CITY OF ALBUQUERQUE

RE: **Lot 13 Block 4 Unit 22 SAD 228
6308 Canavio NW
Volcano Cliffs Subdivision
Grading and Drainage Plan
Engineers Stamp Date 4/26/2021 (D10D003E13)**

DRAINAGE AND TRANSPORTATION INFORMATION SHEET (REV 6/2018)

ENGINEER'S SEAL  4/27/21 DAVID SOULE P.E. #14522	6308 CANAVIO	DRAWN BY: WCVJ
	GRADING AND DRAINAGE PLAN  1606 CENTRAL AVENUE SE SUITE 201 ALBUQUERQUE, NM 87106 (505) 872-0999	DATE 4-26-21 210210034-LAYOUT-3-24-21 SHEET # — JOB # 21021042

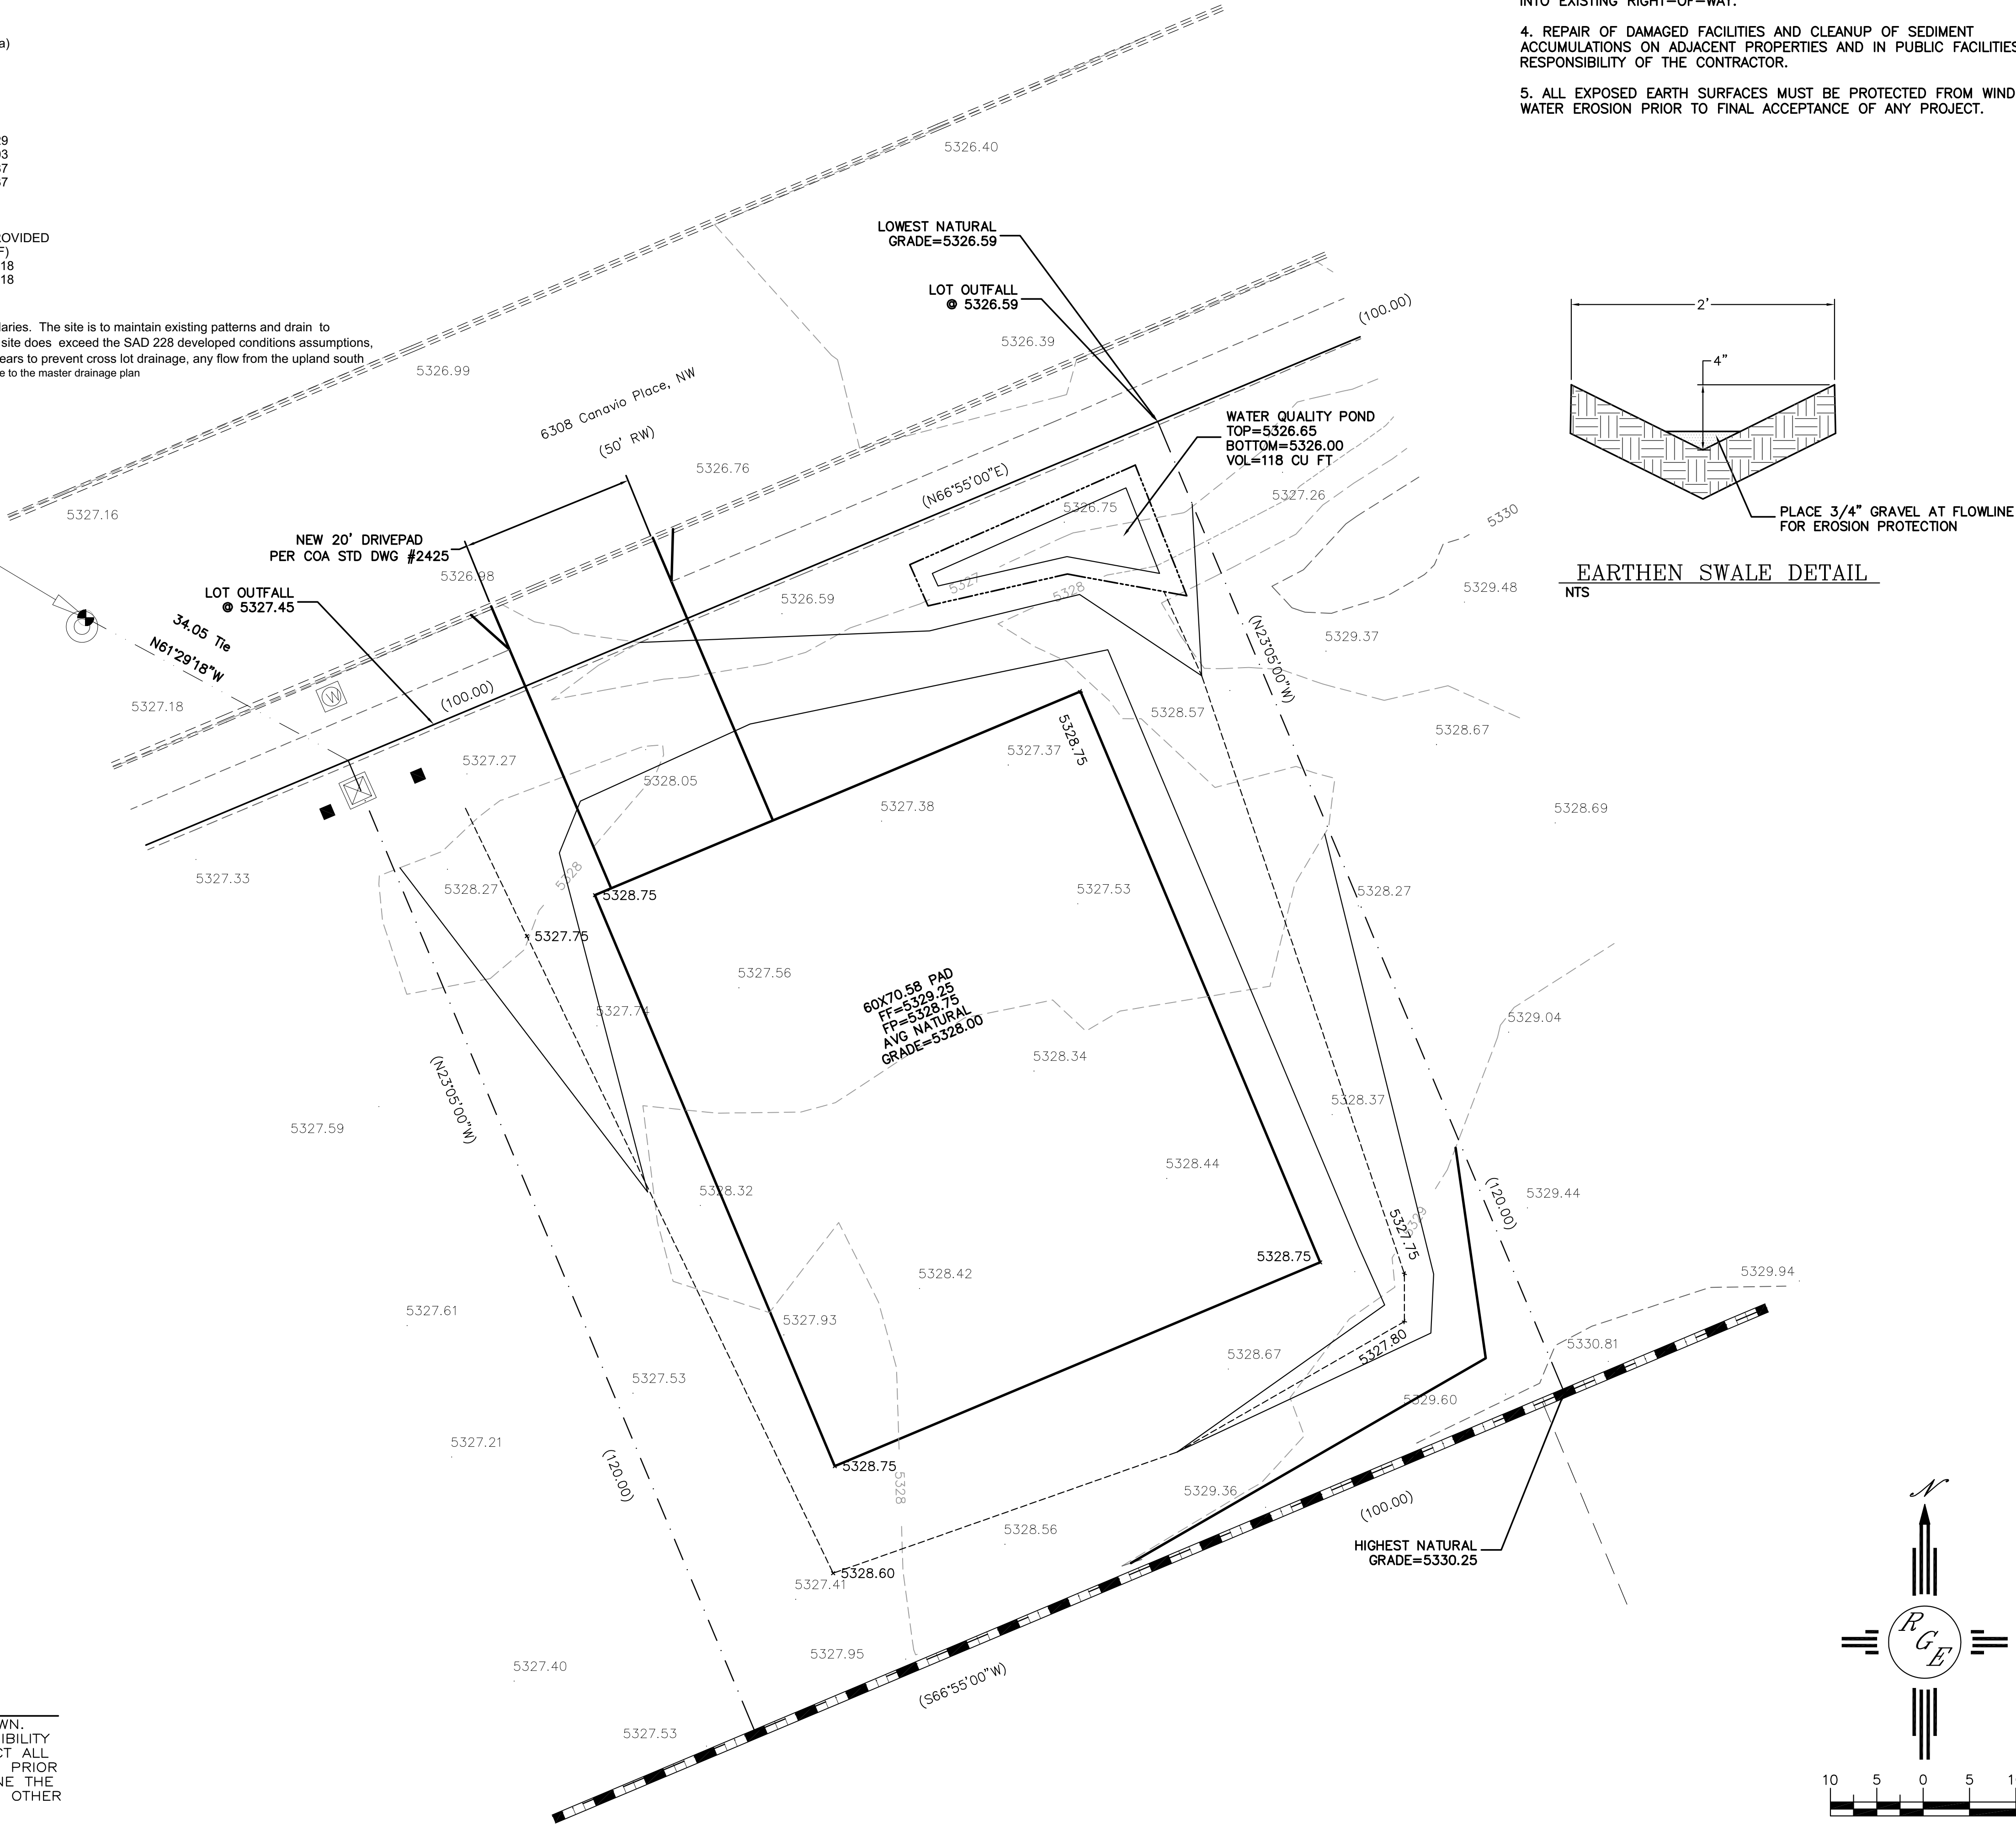
Based upon the information provided in your submittal received 4/28/2021, this plan is approved for Grading Permit.

Prior to Building permit approval a Pad Certification will be required, provided by the Engineer or a registered Land Surveyor.

Advise the owner contractor not to use dirt as a ramp to climb the curb, use lumber or crusher fines for this purpose.

Reiterate to the Owner/Contractor that a separate permit for a garden/retaining wall must be obtained with the approved G&D plan and Pad Certification. Also, if a swimming pool is to be placed the grading and drainage plan will change and will need to be resubmitted.

Prior to Certificate of Occupancy release, Engineer Certification per the DPM checklist is required.
